55

COONARA AVE

WEST PENNANT HILLS

URBAN DESIGN REPORT

CLARIFICATION OF HOUSING PRODUCTS AND LOT SIZES

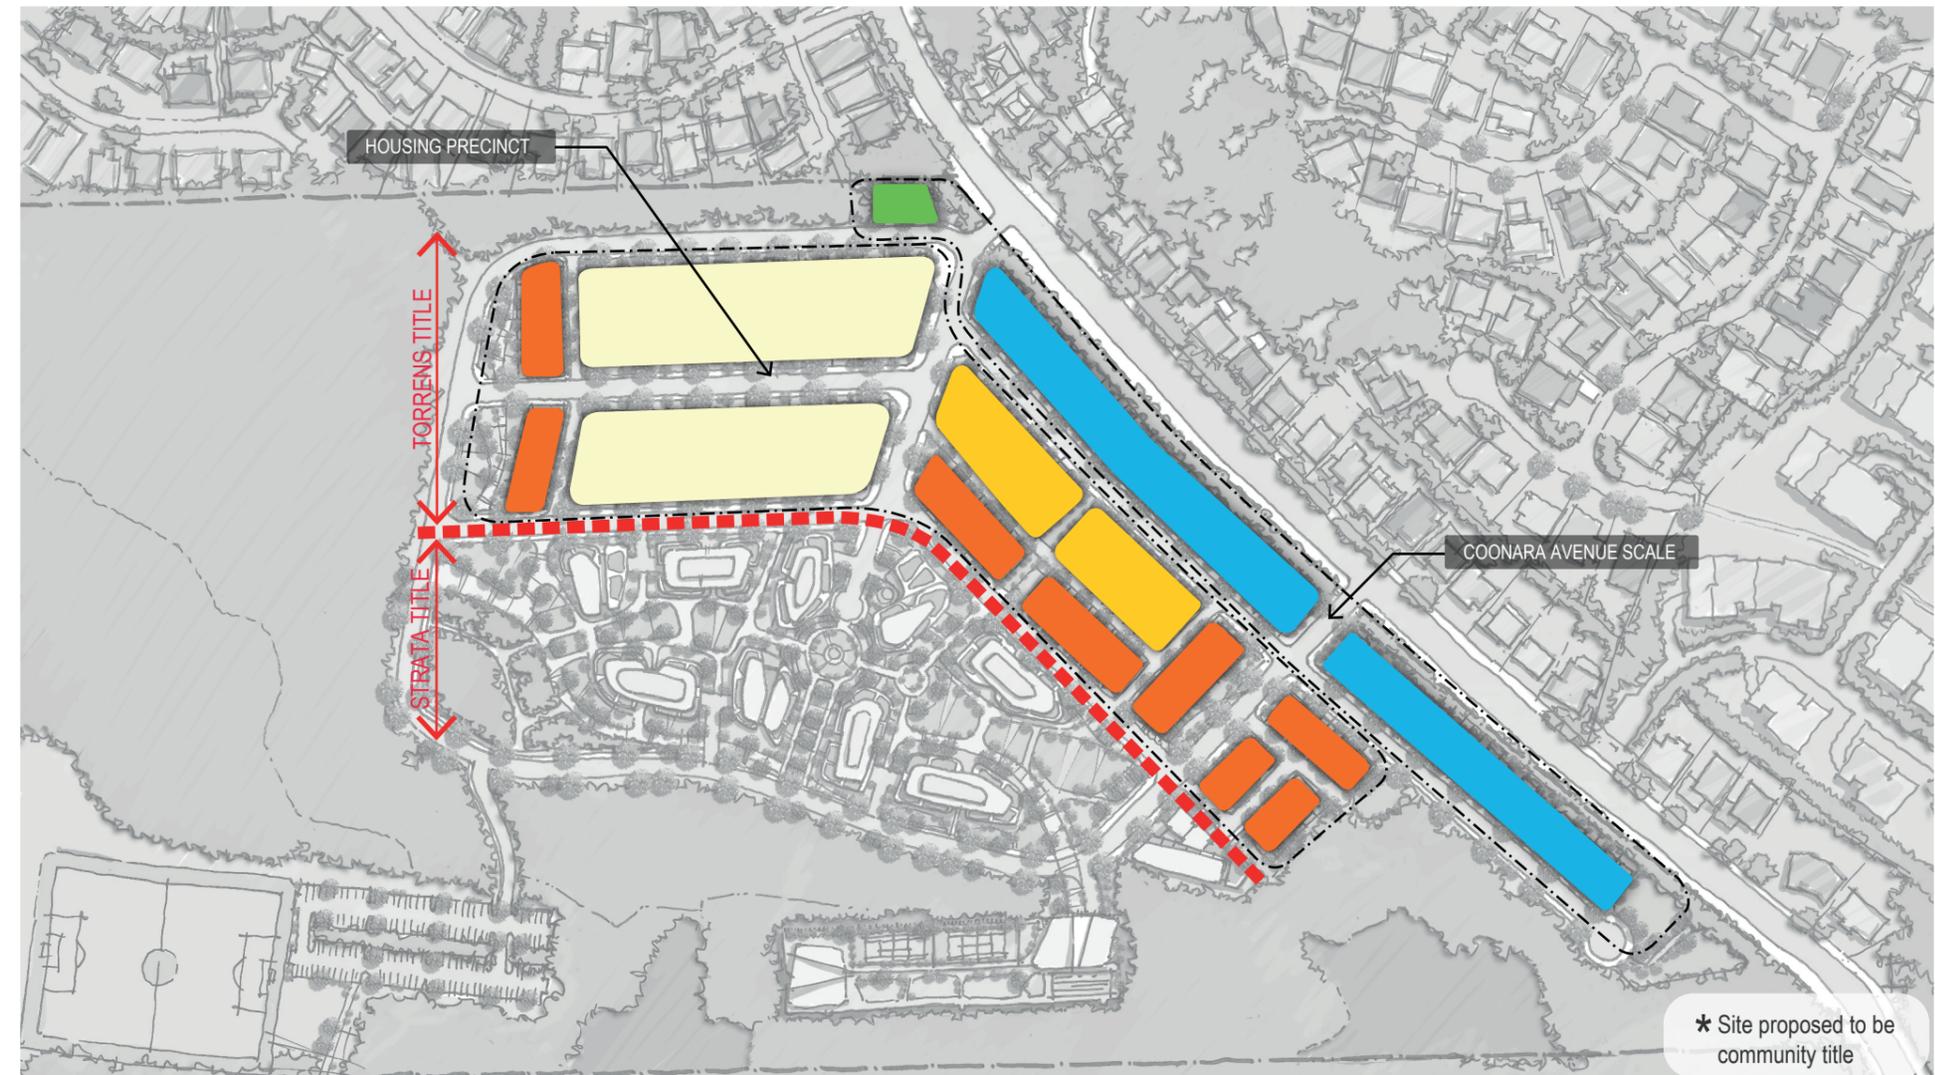
The updated report is noted. Based on the concept plans that have been submitted, it is apparent that there would be a large variety of housing types be provided on the site. However, it is a little unclear as to the type of housing product that will be provided within the 'Coonara Ave Scale', 'Housing Precinct' and 'Community Precinct' and sub precincts within these.

For each precinct, labelled site plans would assist in clearly showing whether dwelling are 2/3 storey terrace, town houses, attached housing, small lot housing, rear loaded, front loaded etc. Further clarity will enable Council to clearly understand the type of housing that will be provided and also inform the most appropriate zone selection to deliver the outcomes. For example within the Housing Precinct area, based on the current site plan some of the housing product appears to be rear loaded terraces, whilst the rest (southern part of the Housing precinct) could be attached or detached dwellings on small lots.

It is noted that the minimum lot size map proposes 100m² (for the housing area). However the concept would indicate that the different housing typologies have different lot sizes. More information is needed on the range of proposed minimum lot sizes for the different sub precincts and the form of titling intended i.e. Strata, Community, Torrens. This could be by way of labelling on the site plan for the different precincts – detailed subdivision plans are not required.

PROPOSED HOUSE TYPES AND LOT SIZES

Typical house types	Lot size
 Front-loaded 2 Storey (attached)	130 - 240 m ²
 Front-loaded 2 Storey (detached)	300 m ²

Typical house types	Lot size
 Front-loaded 2 Storey (detached, semi-detached, attached)	180 - 300 m ²
 Rear-loaded 2 Storey (attached)	150 - 175 m ²
 Rear-loaded 3 Storey (attached)	86 - 126 m ²

CLARIFICATION OF PUBLIC ACCESS

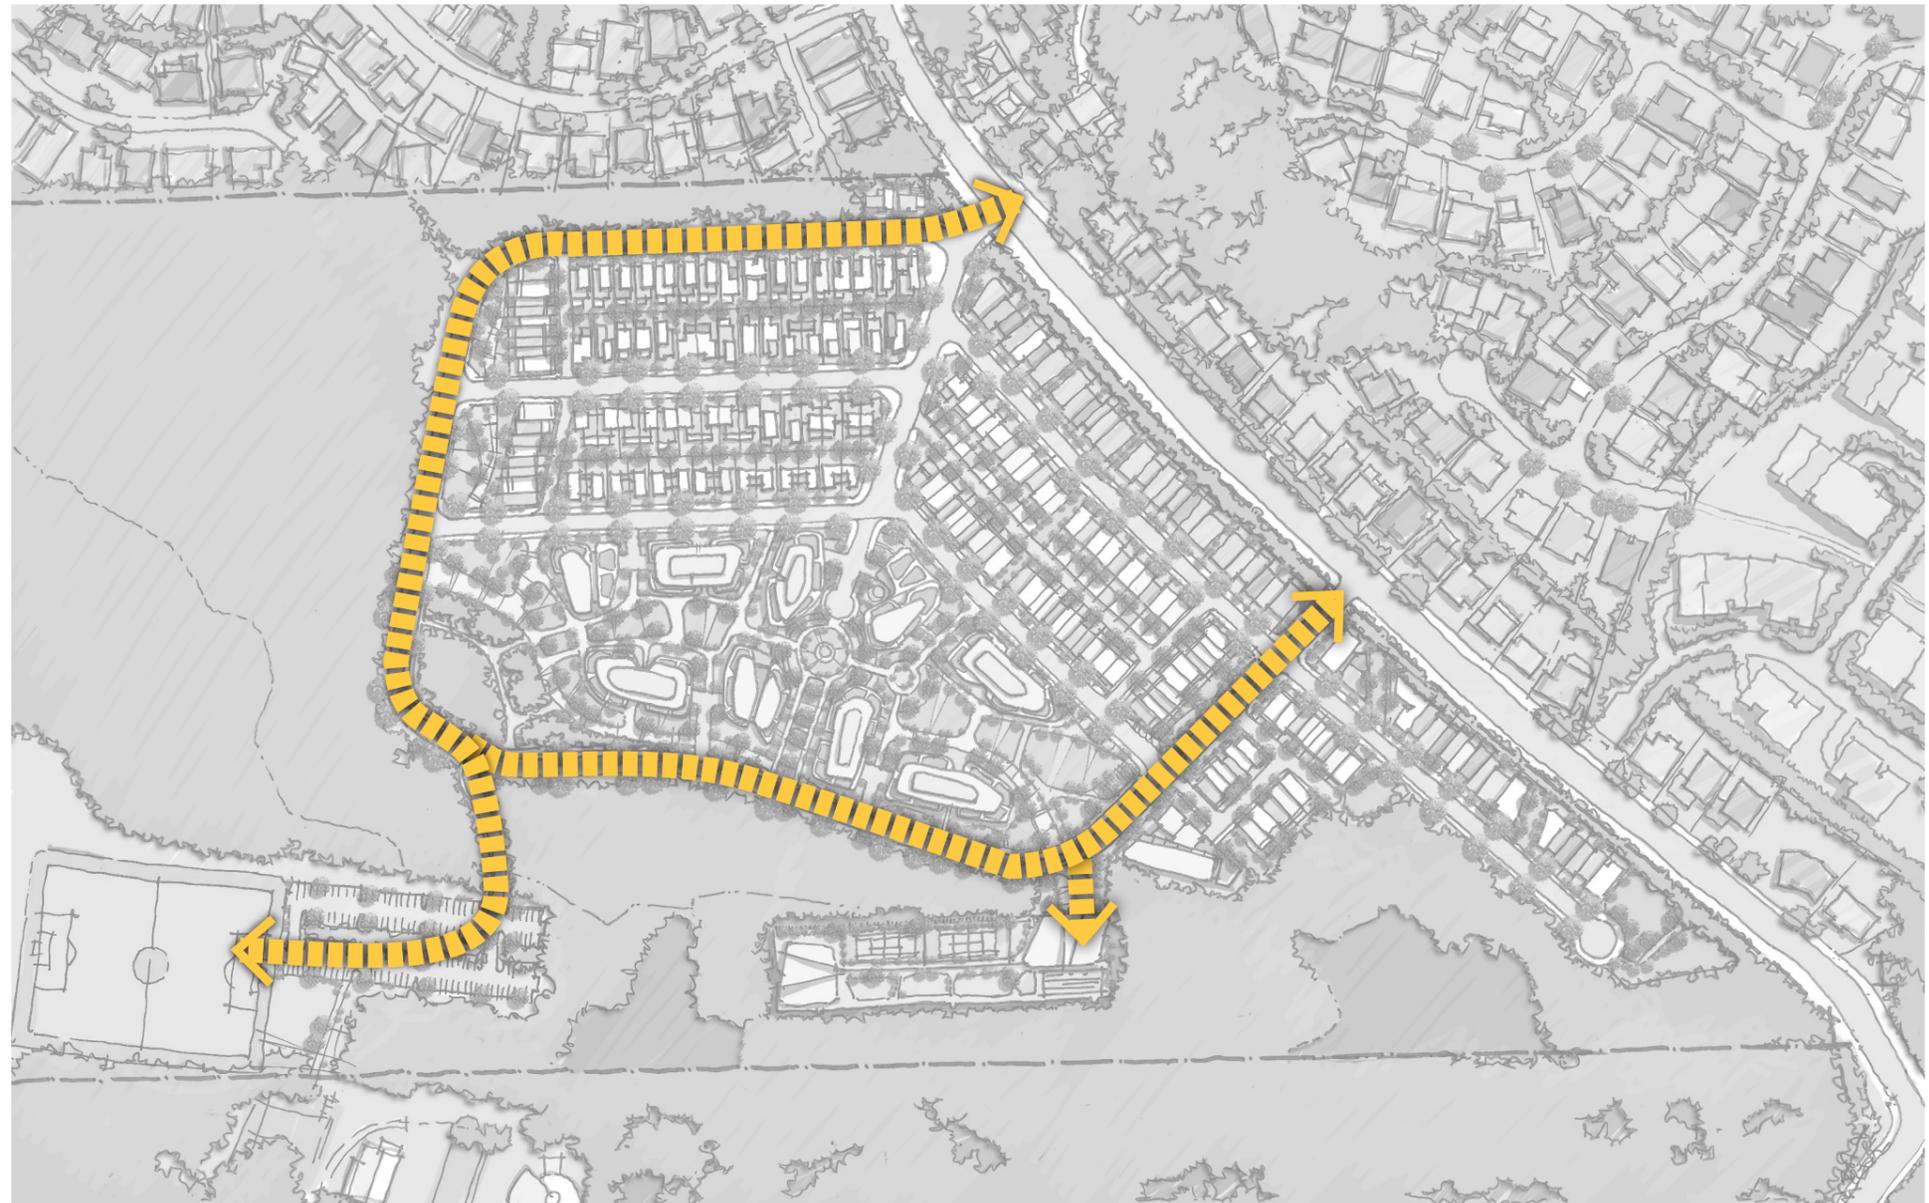
Demonstration of public access to future infrastructure. It is noted that the VPA proposes a new playing field toward the rear of the site. If this is to become a public asset it would need to be accessible via a public road which would connect to the existing public road network. Whilst it appears as though the development would occur as part of a community title subdivision clarification is required as to what roads would be private roads and what roads would be dedicated as public road.

Access to all public facilities including the playing field and the community centre is provided via the primary vehicular access road that circumnavigates the site.
